**Request for Bid
John's Creek Interceptor CIPP Addendum No. 1 to
RFB No. 196182.71.0395
June 23, 2017**

Section 2 – Technical Drawing NS-9 PP 17

**Section 2
Technical Drawing NS-9 PP 17**

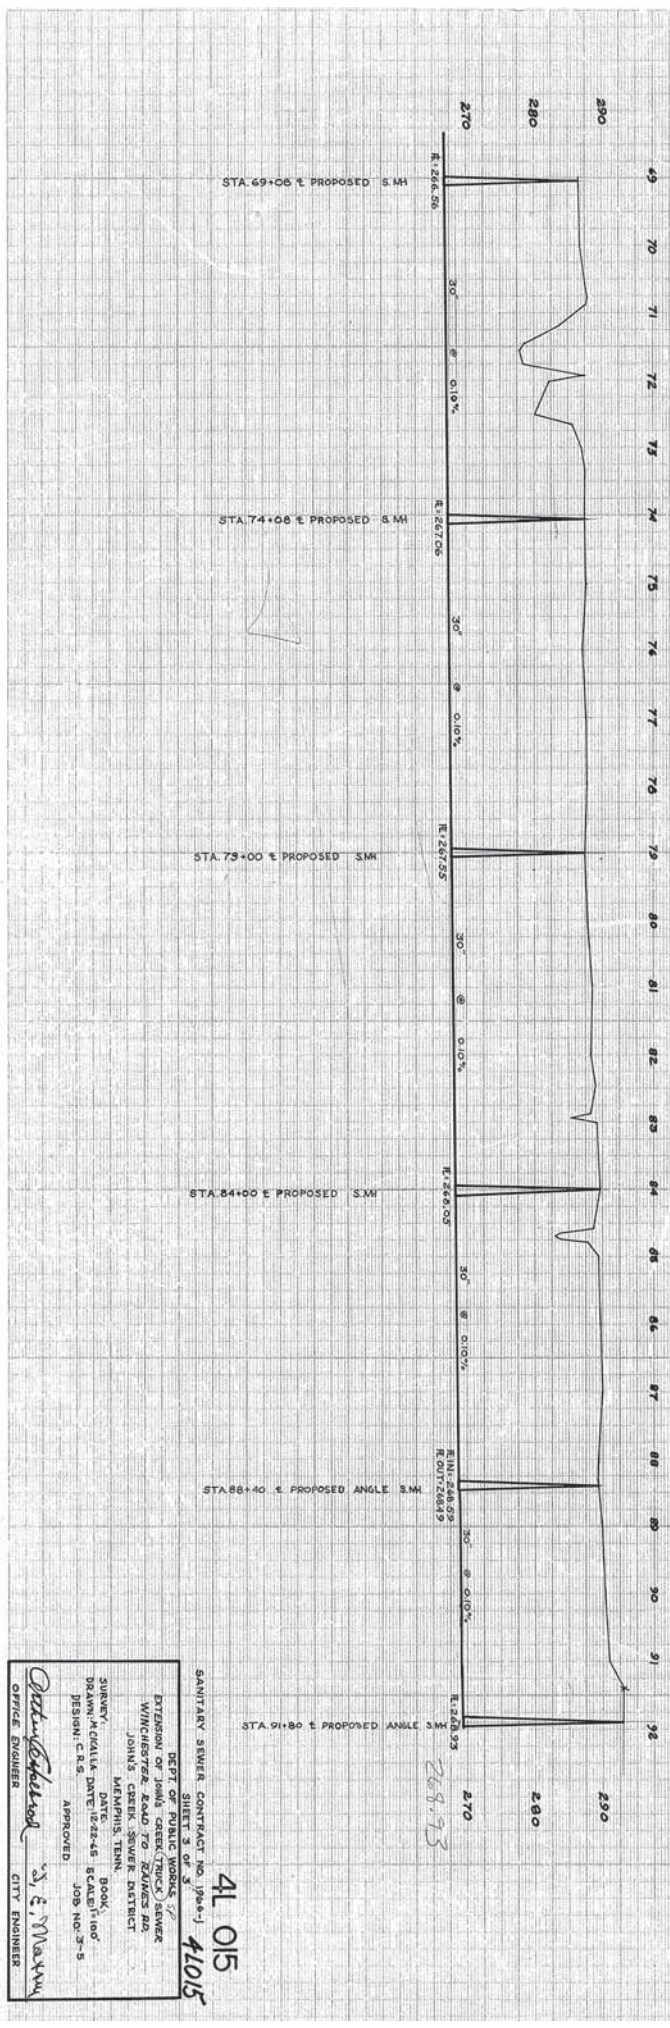
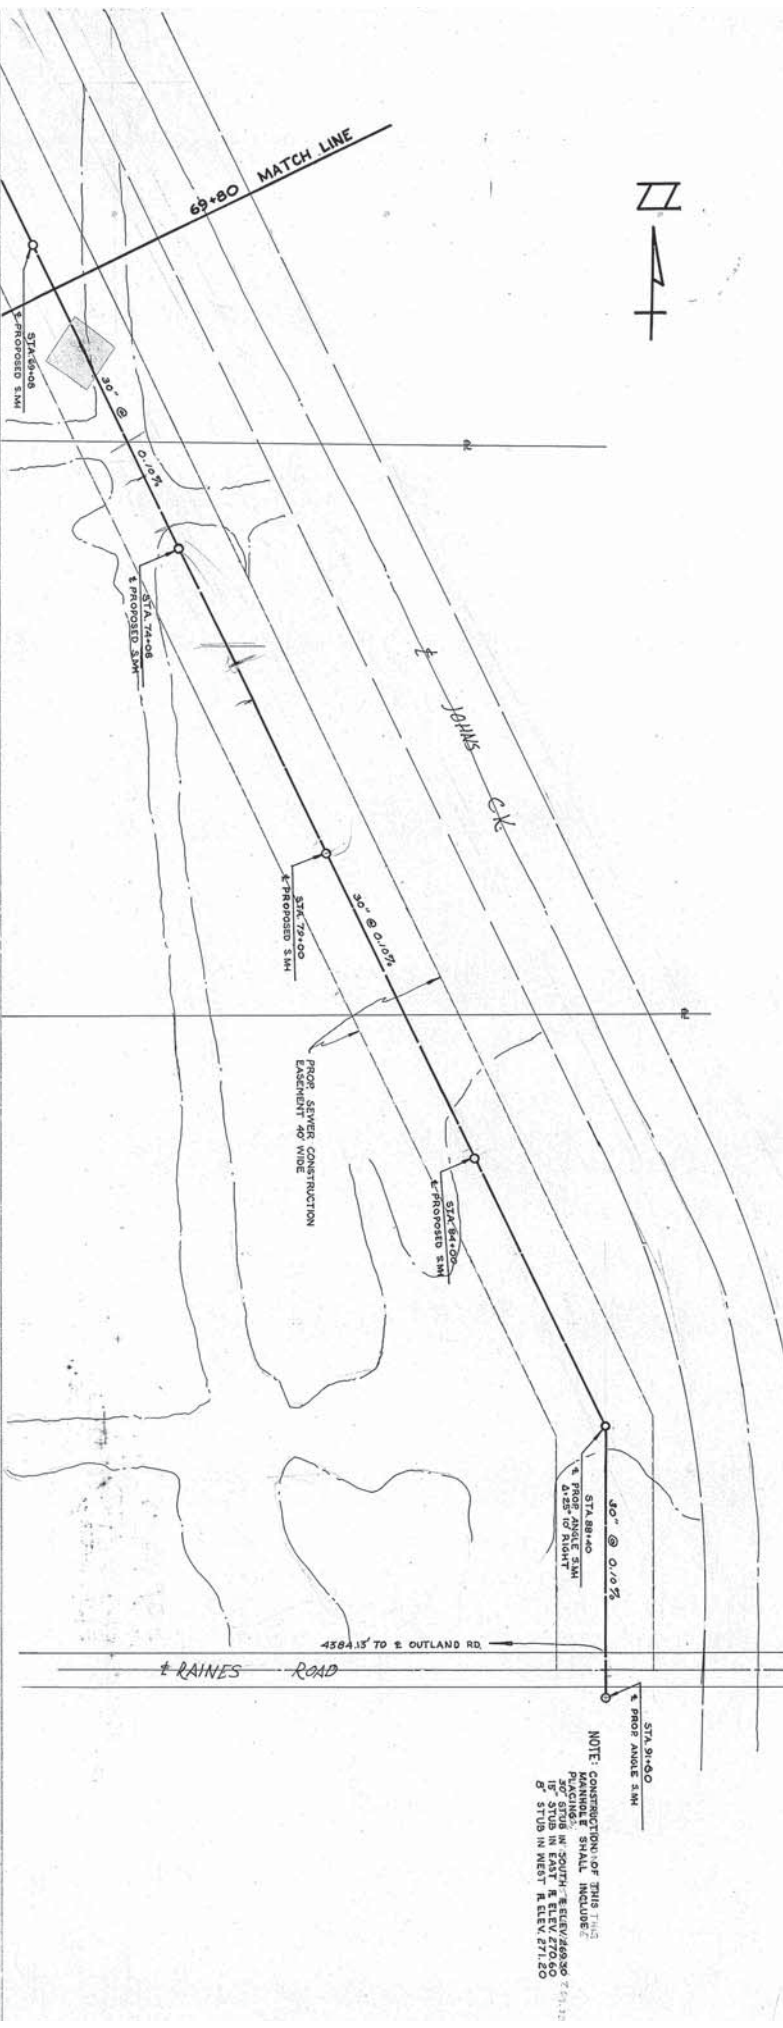
Q1: What is the slope of the sanitary sewer line that is being rehabilitated?

SARP10: The as-builts drawings show a slope of 0.10%. SARP10 cannot verify the actual slope for this line. See plans included in this Addendum.
